Re: Boulger Dam / UT00695 - Skyline Subsidence Memorandum (April 21, 2017)

Mine 4
Mine Plan
2017

Canyon Fuel Company, LLC
Skyline Mines

HCR 35 BOX380, HELPER, UT, 84526 435-448-2632	DATE: 12/30/2016	CK.BY: G.Galecki	REVISION: 2017
CAD FILE: 3.1.8-3REV2017	SCALE: Full	DR.BY: J.Armstrong	12/30/2016
DWG. NO.: 3.1.8-3(2017)

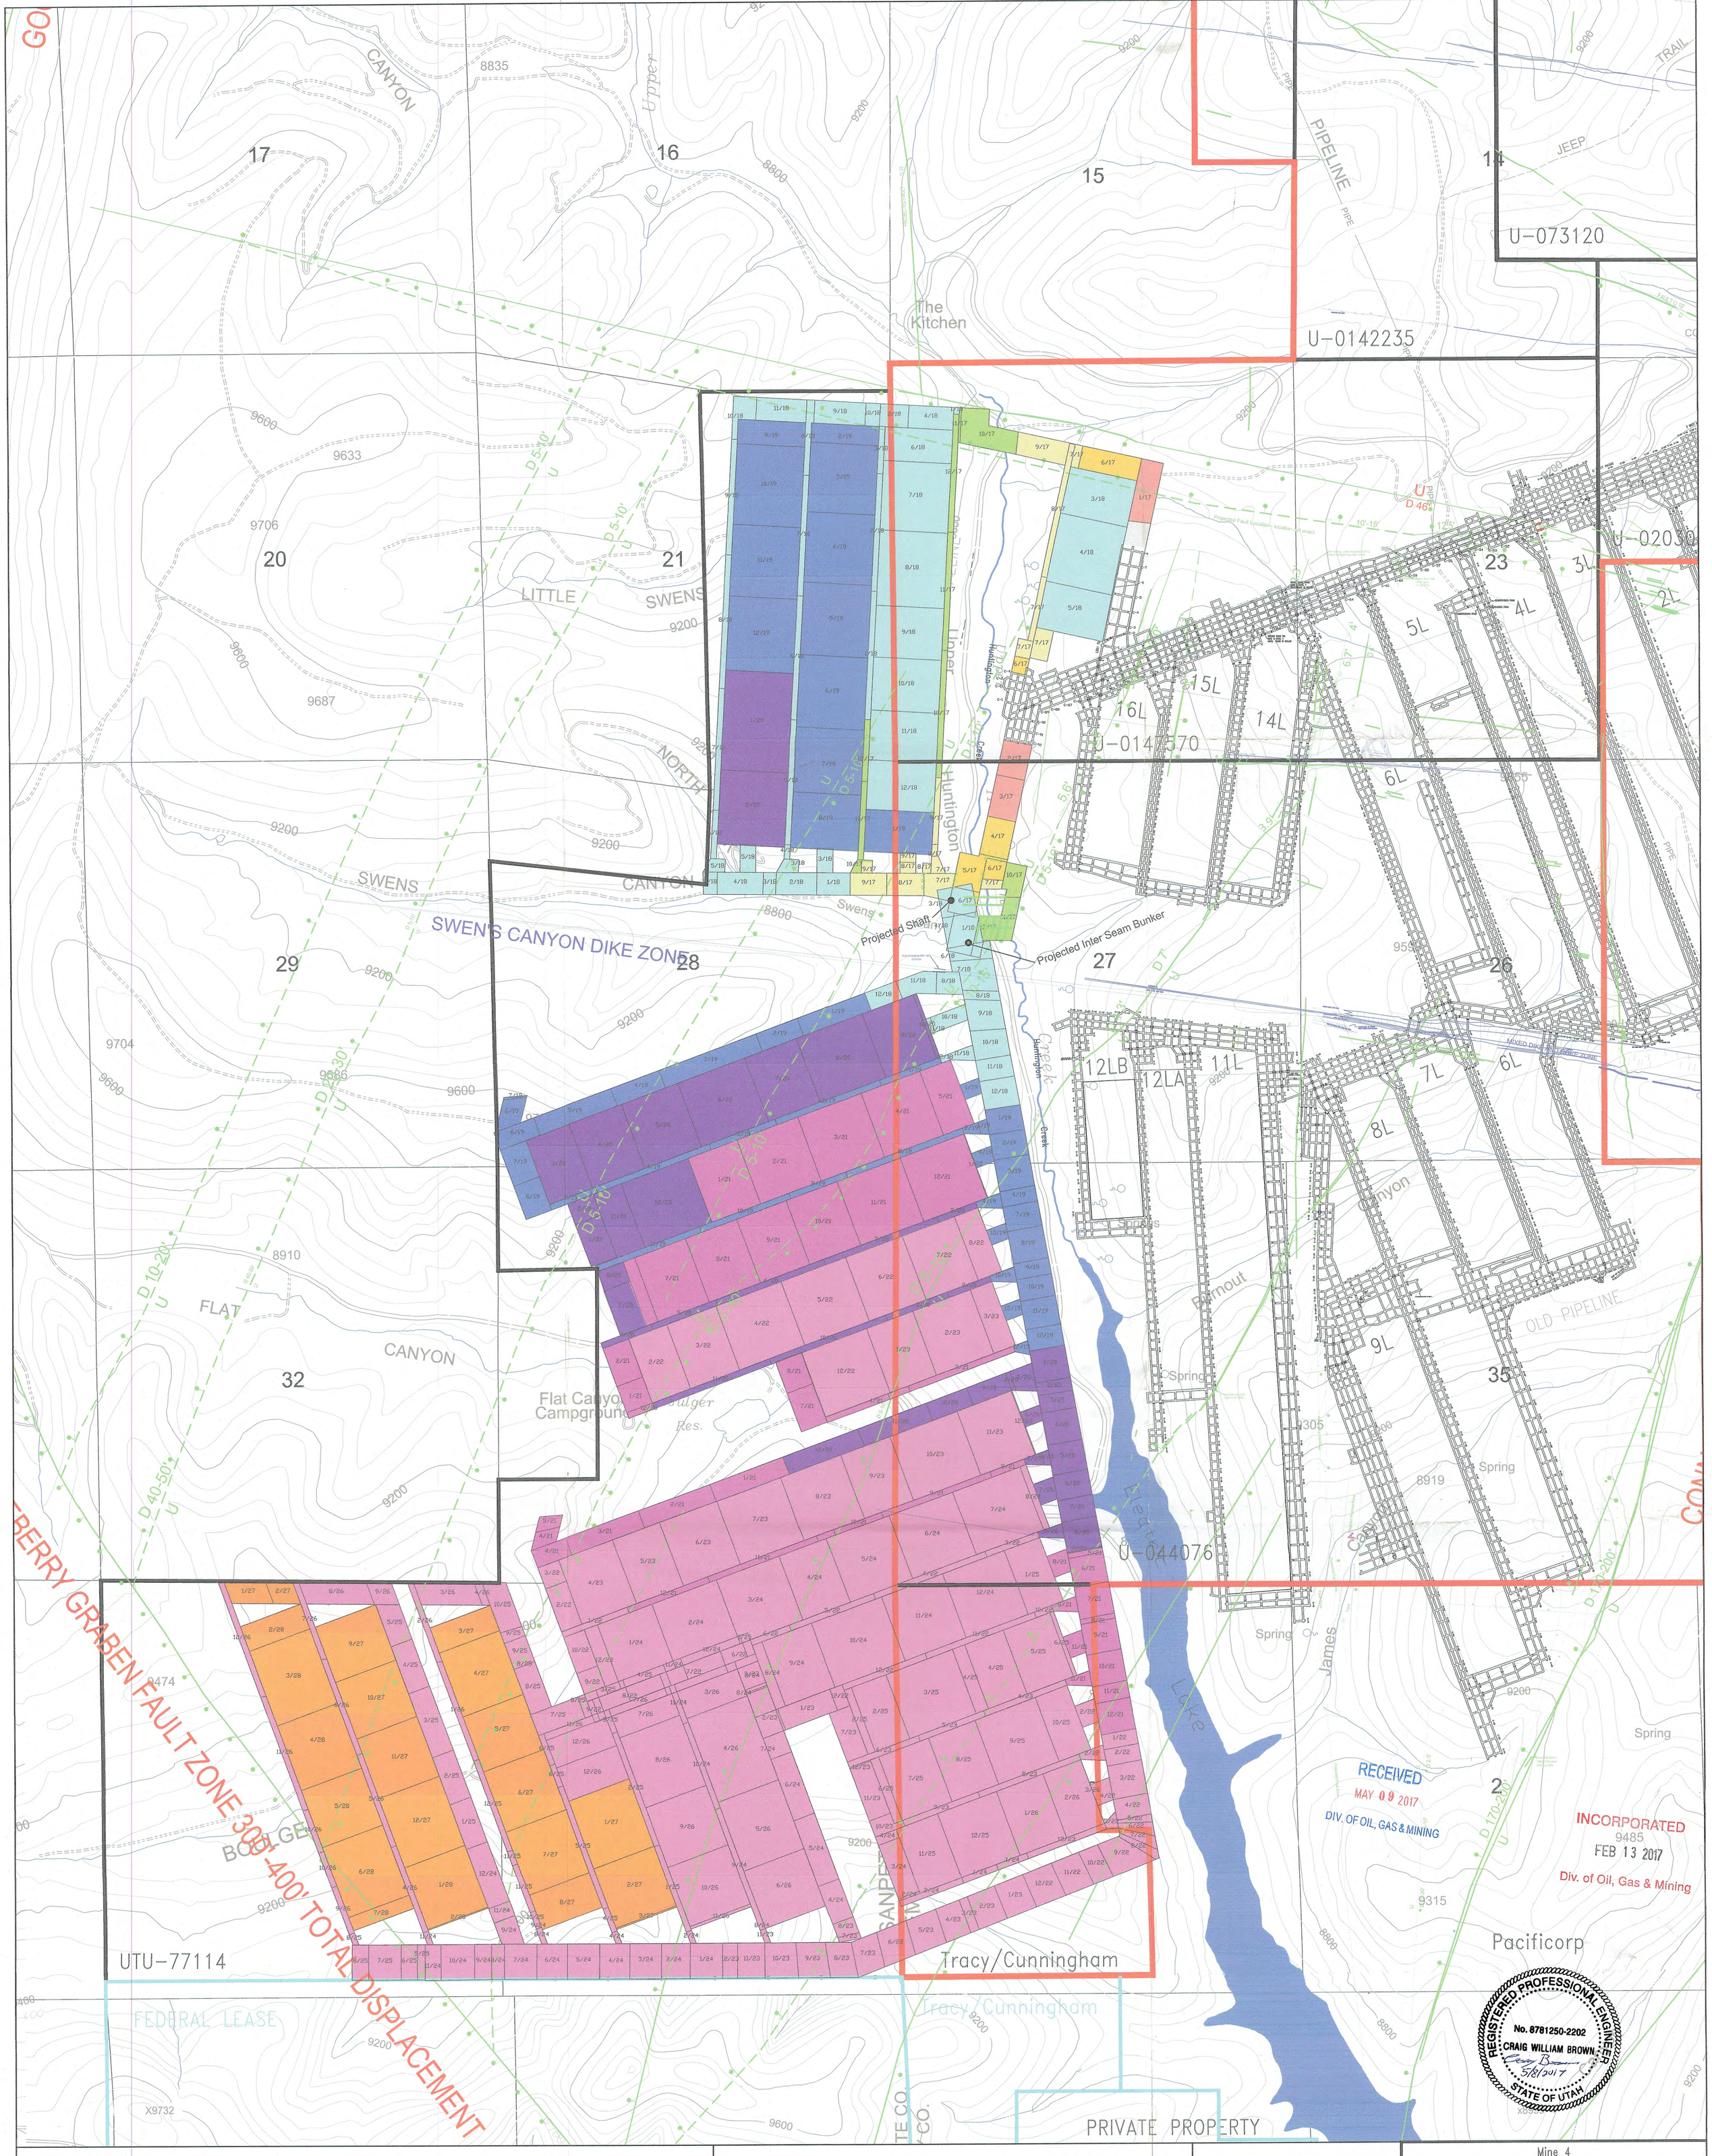
Per our conversation earlier this morning, I've attached Plate 3.1.8-2 . The plate depicts the mine plan that was recently approved as part of the Flat Canyon Lease addition. Once you've had a chance to review it, let us know what your finding is relative to the Boulger Reservoir monitoring that Skyline discussed in it's April 2017 memorandum.

It is noted that the panel layout and location as shown in the April 2017 memorandum is different from what Dana Dean originally sent to our office in February 2017. The layout that Dana sent shows the south panel about 250-feet away from the dam, while the April 2017 memorandum shows the south panel shifted further to the south and about 750-feet away from the dam. We're assuming that the layout shown in the April 2017 memorandum is the correct layout. Please verify.
